OFFSHORE POWER SYSTEMS

DOCKET NO. STN 50-437

INSTRUCTIONS FOR ENTERING AMENDMENT NO. 28

IN THE PLANT DESIGN REPORT

TABLE C-11

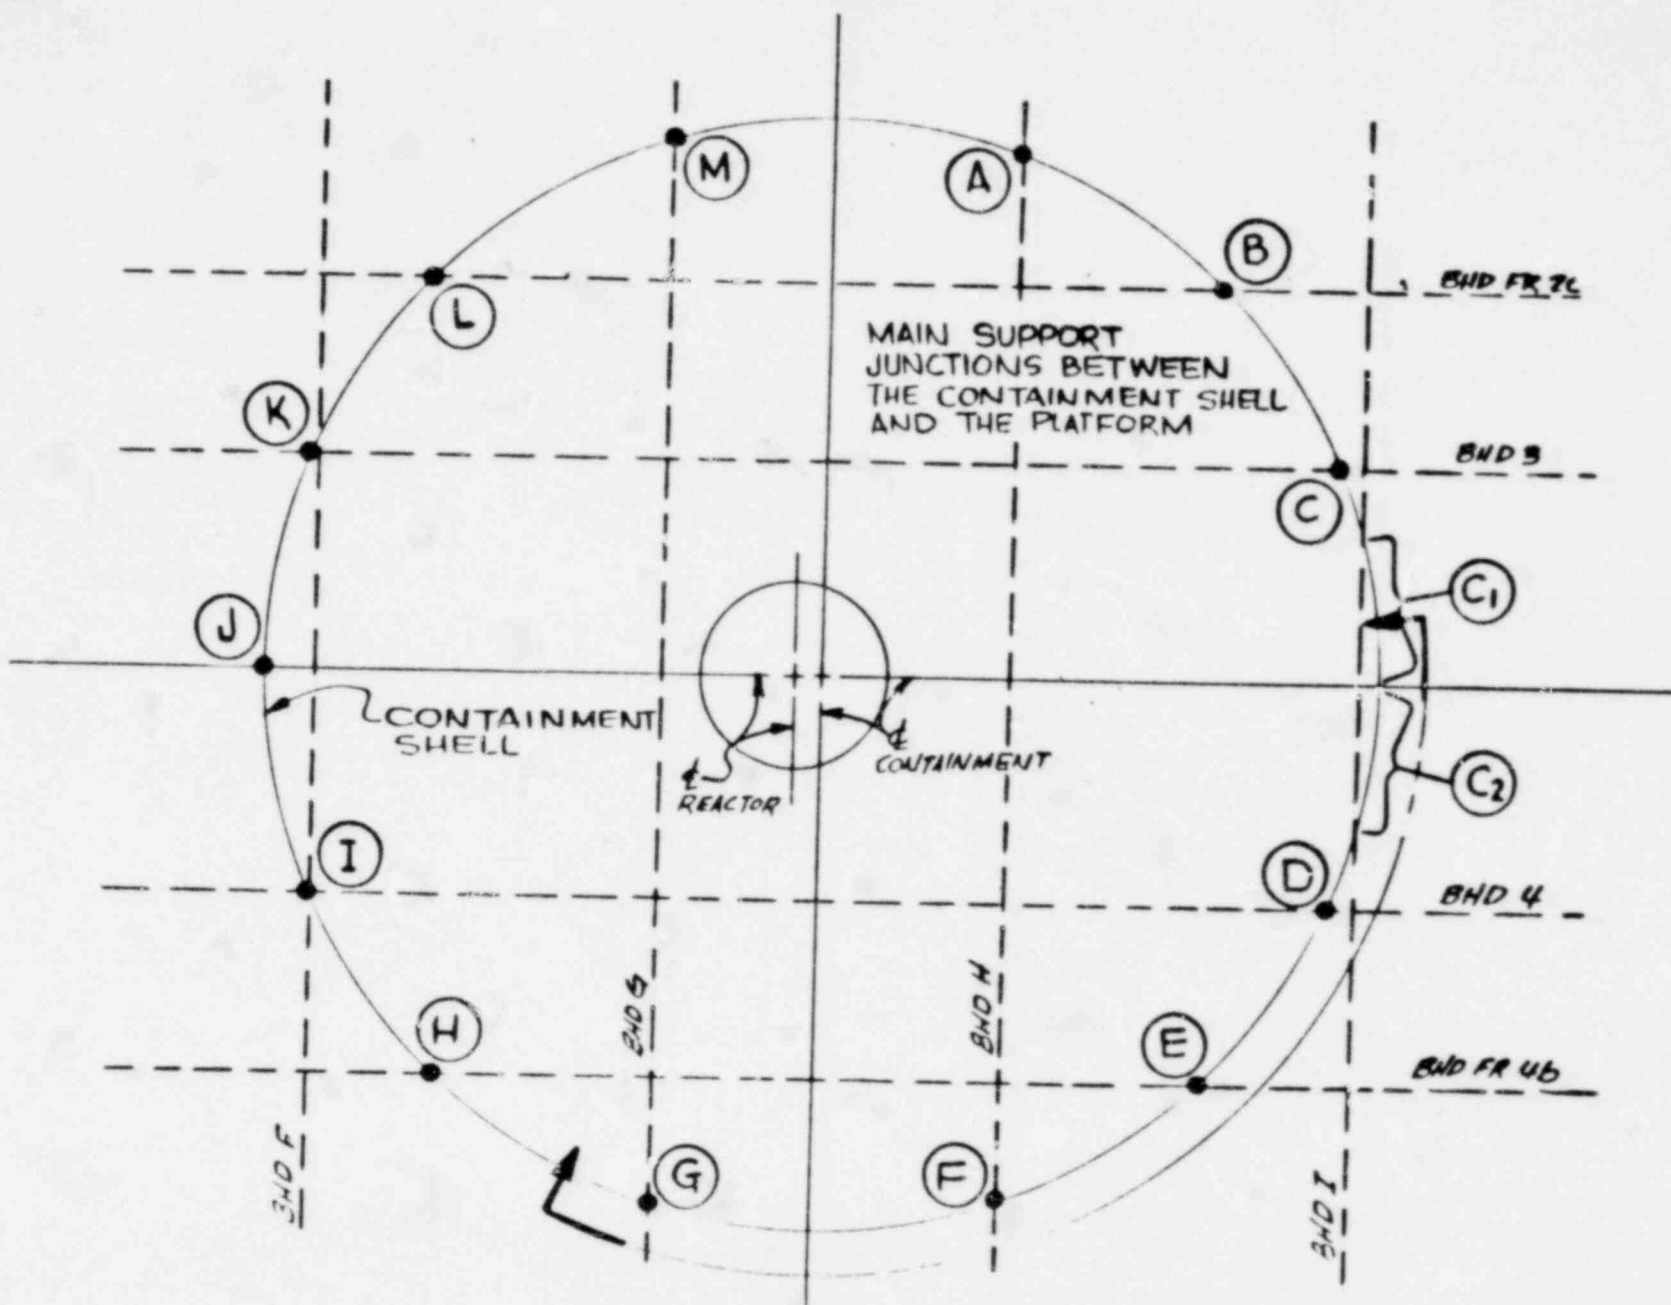
1. INCREASE THICKNESS OF SHELL (ELEVATION 199'4" TO 224'0") FROM 5/8" TO 1".
2. INCREASE THICKNESS OF SHELL (ELEVATION 162'2" TO 199'4") FROM 7/8" TO 1".
3. INCREASE CAPABILITY OF EQUIPMENT HATCH COVER BY ONE OF THE FOLLOWING:
 - A) INCREASE THICKNESS FROM 1-3/8" TO 1-3/4".
 - B) ADD STIFFENERS TO PREVENT BUCKLING.
 - C) REVERSE ORIENTATION SO THAT PRESSURE ON COVER IS INTERNAL PRESSURE.
